HOWARD COUNTY HEALTH DEPARTMENT

October 5, 1987

RE: Percolation Testing-Repair
Proposed Addition to
Septic System
11865 Lime Kiln Road

PLOT PLAN

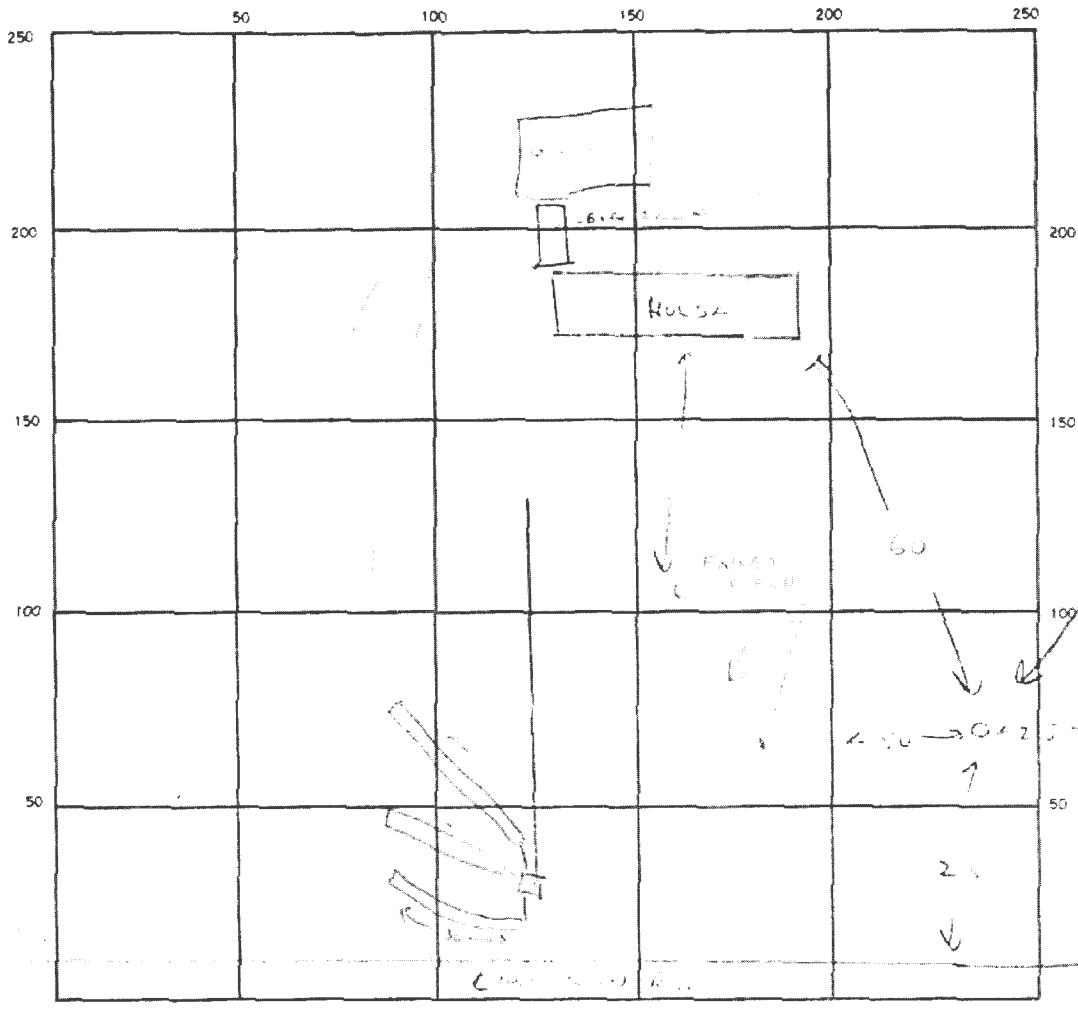
DATE	TEST #	DEPTH	START	BREAK 1" DROP	STOP 2" DROP	TIME OF 2ND INCH	P/F/H
8/26/15	1	5.7/105	2:04	2:06	2:09	3	P
8/26/15	2	4.2/89	2:56	3:46			F
8/26/15	3	6.5/105	3:20	3:27	3:35	8	P
8/26/15	7	105	Visual	3'-6.5' sidewall	1.2 gpd/G2		P
* Observed water table in other locations and collapse of shell at #1 may indicate presence of saturated soils at location #1 approx. 28' - 5.8' - 14' - 11'

DIAGRAM
WILLIAM REED
INCORRECT
11/10/88
